## NOTICE OF ADOPTED CHANGE TO A COMPREHENSIVE PLAN OR LAND USE REGULATION

Date: 10/24/2014  
Jurisdiction: City of Hood River  
Local file no.: 2014-11  
DLCD file no.: 001-14

In the Matter of a Comprehensive )  
Plan/Zoning Map amendment ) **FINDINGS AND DECISION**  
by the Port of Hood River, and Site )  
Plan Review by Key Development )  
Corporation, File No. 2014-11 )

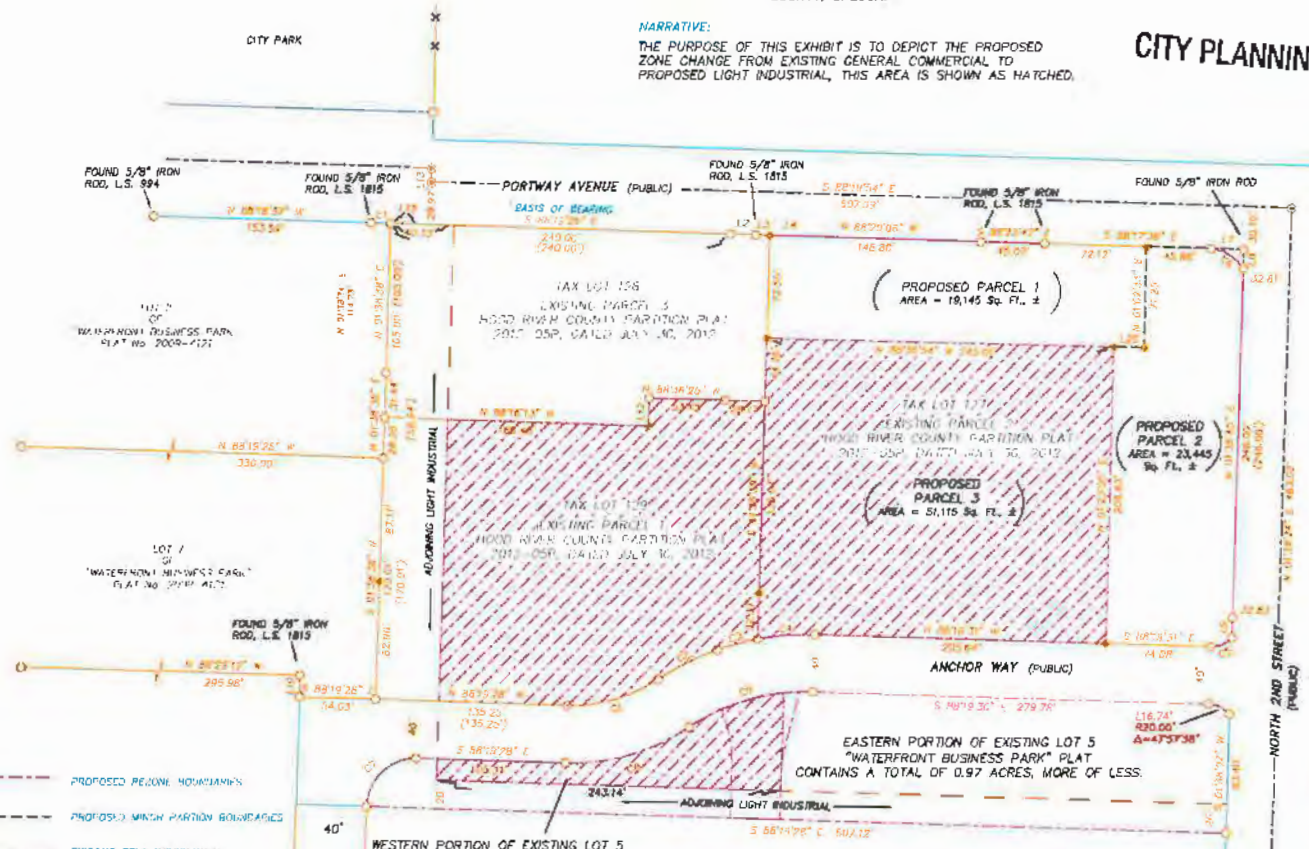
**NARRATIVE:**  
THE PURPOSE OF THIS EXHIBIT IS TO DEPICT THE PROPOSED  
ZONE CHANGE FROM EXISTING GENERAL COMMERCIAL TO  
PROPOSED LIGHT INDUSTRIAL. THIS AREA IS SHOWN AS HATCHED.
